**Beaver Valley Power Station
Unit Nos. 1 and 2**

**License Amendment Requests
302 and 173**

Extended Power Uprate

L-04-125

Figure 4.2-6

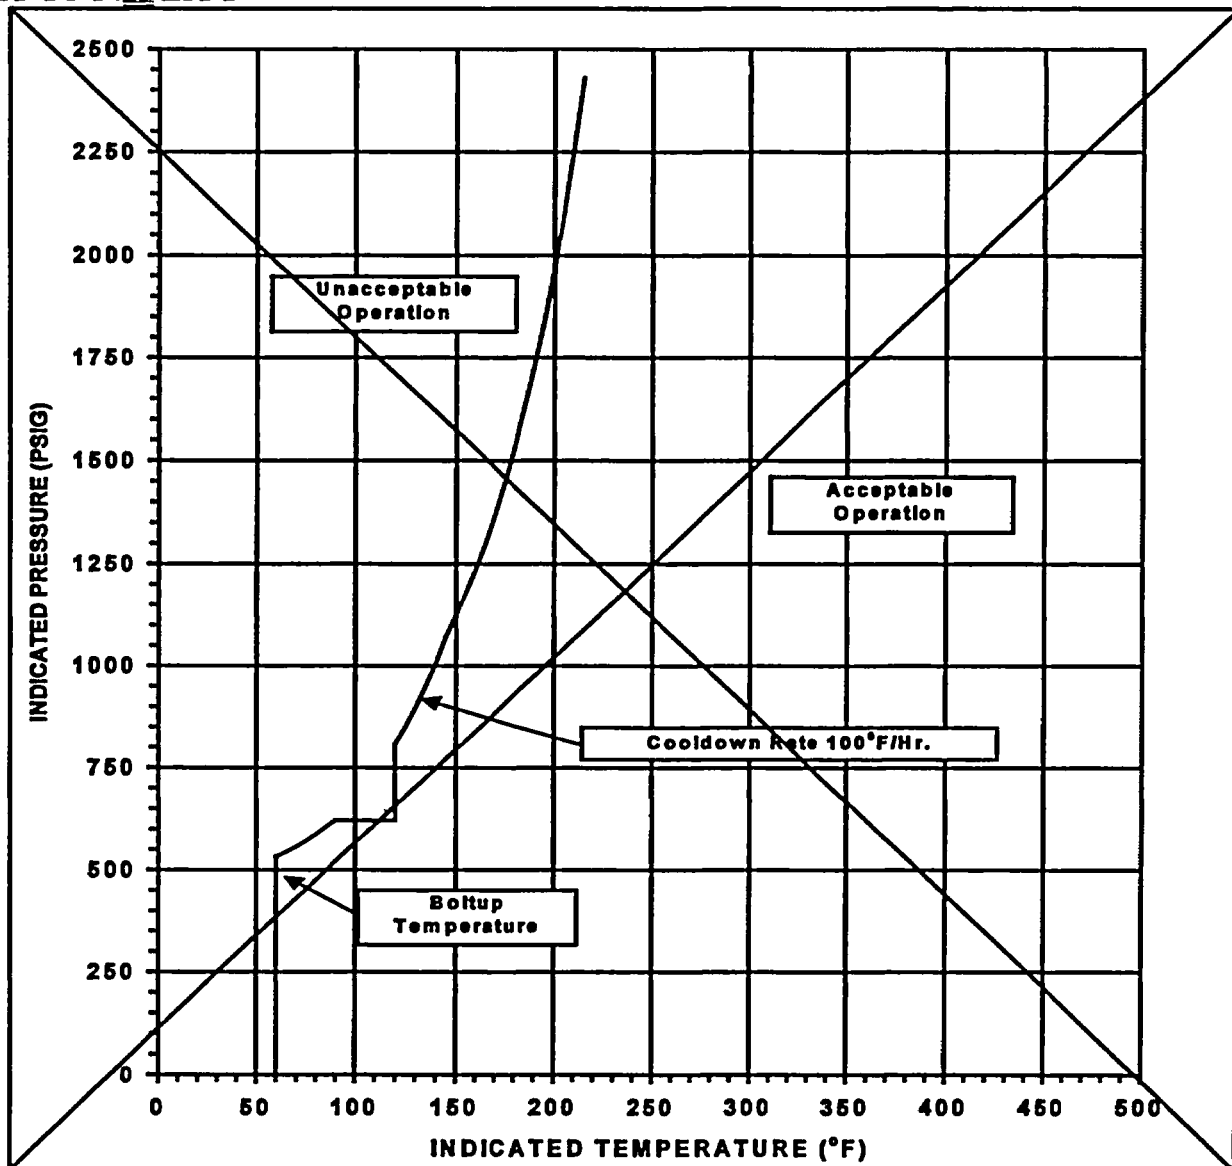
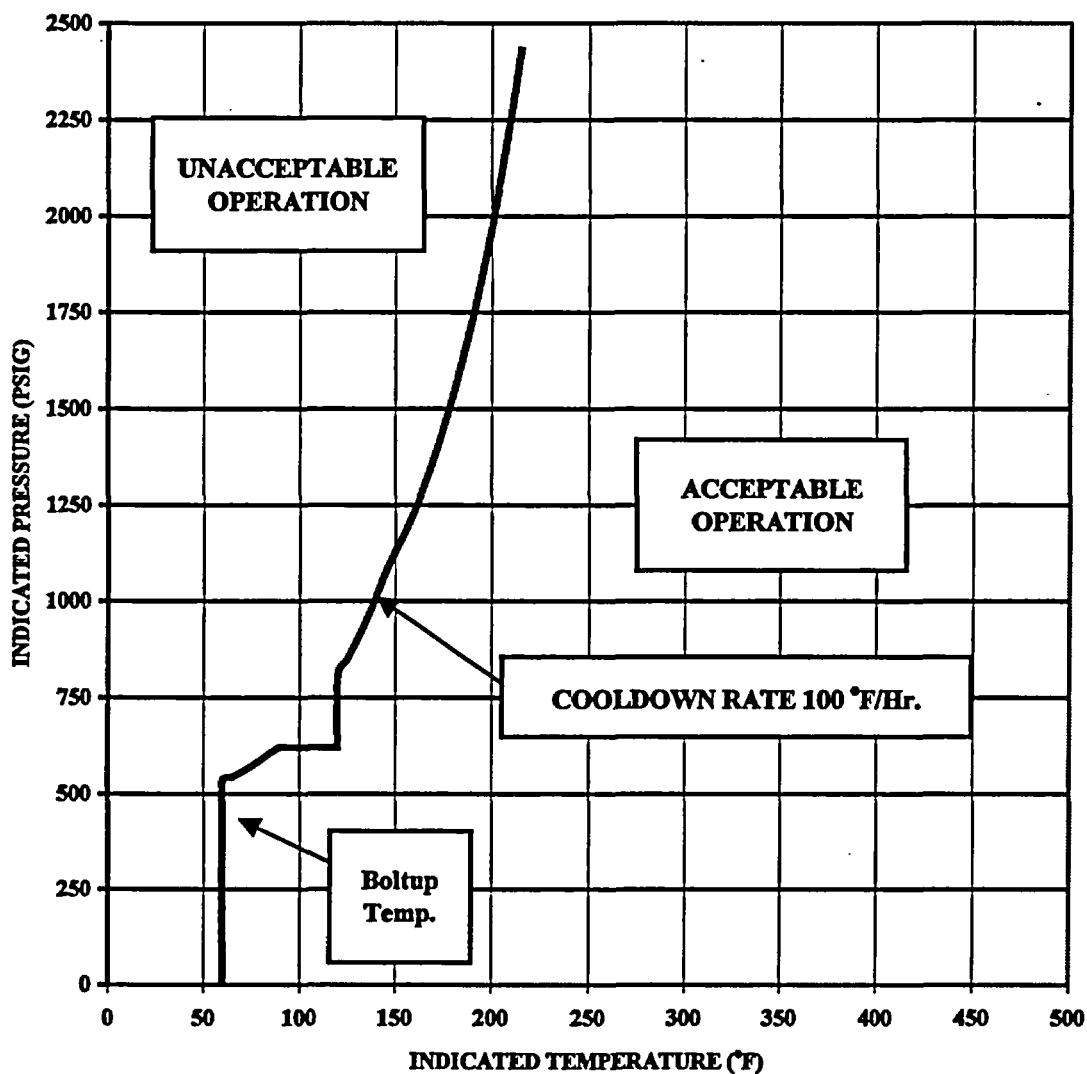
3/4T, 128129°F

Replace with
Insert C2-9.

Insert C2-9.
